T ECHNICAL INFORMATION

74342

- Subject** ▶ Change of Ring Spring 19, Baffle Plate and Armature Ass'y
- For Models** ▶ HR2020, HR2021, HR2022, HR2432, HR2440, HR2440F, HR2441, HR2442, HR2445, HR2450, HR2450F, HR2450T, HR2450FT, HR2451, HR2452, HR2455
- Country** ▶ All countries
- Description** ▶ Ring spring 19, Baffle plate and Armature ass'y have been changed as illustrated below.

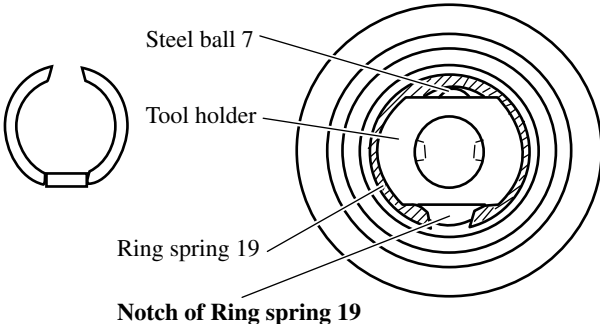
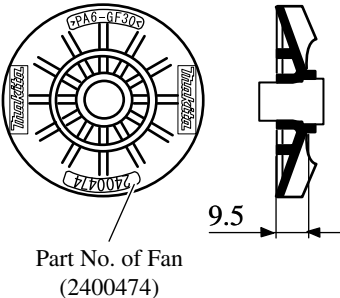
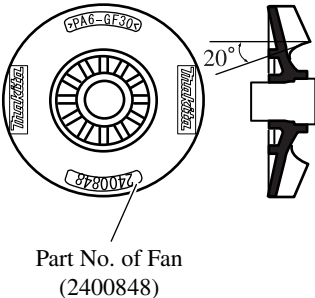
► Current	► New
<p>Ring spring 19</p> <p>As illustrated to the right, notch of the ring spring 19 should be at opposite side of Steel ball 7.</p>		
<p>Baffle plate</p> <p>The baffle plate of HR2445 and HR2455 remain the same. (Part No. 418085-6, Item No. 058)</p>	<p>Part No.(4176312)</p> 	<p>Part No.(4192013)</p> 
<p>Armature ass'y</p> <p>Distinguish the new Armature ass'y from the new by checking the Fan (that is the component of Armature ass'y.)</p>	 <p>Part No. of Fan (2400474)</p>	 <p>Part No. of Fan (2400848)</p>

Item No.	Current part		Q'ty	I/C	New part		Q'ty	Note
See below.	Ring Spring 19 233915-8		1	Yes	Ring Spring 19 233940-9		1	
See below.	Baffle Plate 417631-2		1	Yes	Baffle Plate 419201-3		1	Except for HR2445 and HR2455
See below.	Armature Ass'y See page 1.		1	Yes	Armature Ass'y See page 1.		1
